GLOBAL SAFETY FIELD INVESTIGATIONS
DCS6574
URGENT - DISTRIBUTE IMMEDIATELY

Subject: N222382520 - Service Update
Intermediate Steering Shaft Bolt

Models: 2023 Cadillac LYRIQ

N222382520 Intermediate Steering Shaft Bolt

6196305

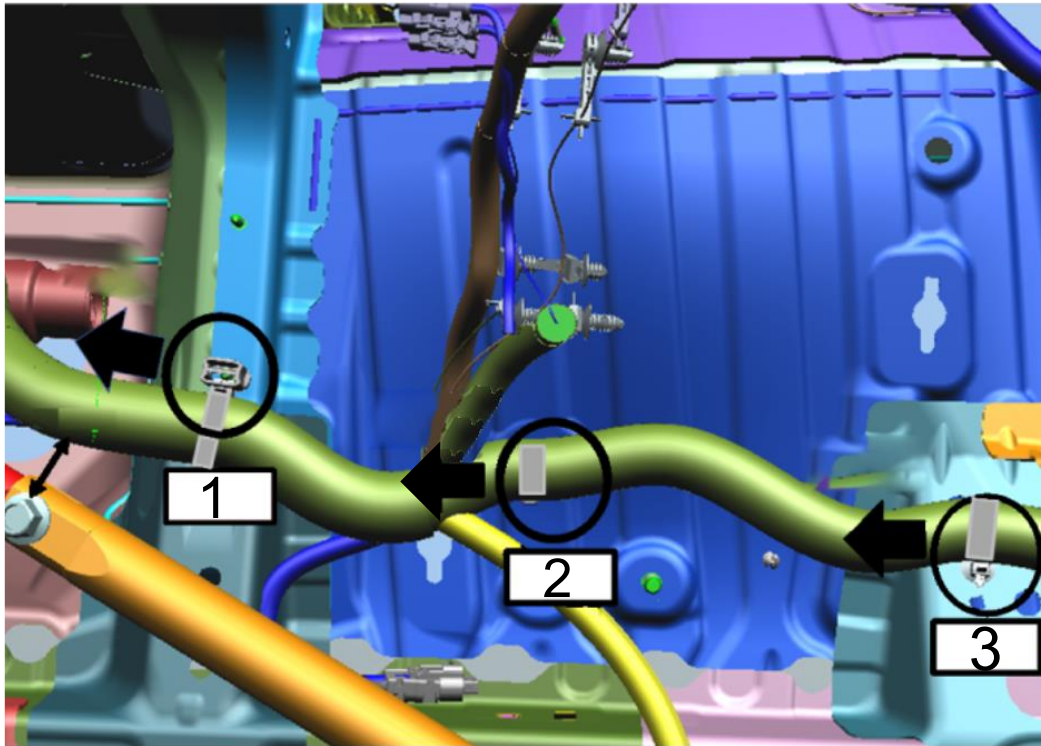
2. Rotate the steering wheel so that the intermediate shaft bolt has the threaded end pointing towards the wire harness secured to the strut tower, as shown.

3. Using feeler gauges, calipers, or another convenient measuring tool, check to ensure the distance between the intermediate shaft bolt and the body wiring harness is **at least** ¼ inch (7 mm).

- If the distance between the intermediate shaft bolt and the body harness is at least ¼ inch (7 mm) proceed to step 5.
 - If the distance between the intermediate shaft bolt and the body harness is **not** at least ¼ inch (7 mm), replace the bolt with the part number provided in the parts list for this field action, torquing to 43 lb ft (58 N-m) then proceed to step 4.

- If there is any damage from the intermediate shaft bolt rubbing the body harness, repair the damage at this time. Refer to *Wire-to-Wire Repair* in SI.

4. With the intermediate shaft bolt still oriented so the threaded end faces the body harness, recheck the clearance in the same fashion as step 3.
 - If the distance between the intermediate shaft bolt and the body harness is at least ¼ inch (7 mm) proceed to step 5.
